Access Compliance Report Public Rights-of-Way (Curb Ramps)

Intersection ID: 13432 Main Street: E_8TH_ST Cross Street: LOUISE_AV Location: E

ADA ID: 51D3E58D5CE6 Ramp Type: PerpDiag Initial Pass/Fail: Fail Overall Compliance: No Severity Score: 18.75

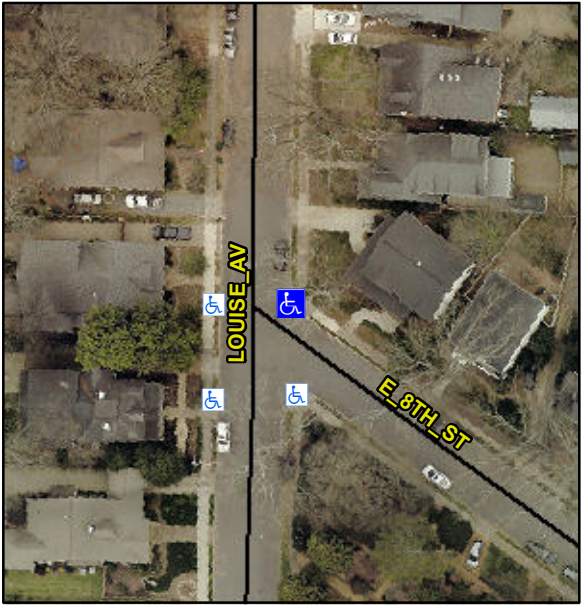
Possible Solutions:
Remove & Replace Curb Ramp With Two New Directional Ramps or Equivalent.

PROW/ADA:
R304.5.1, R304.5.3
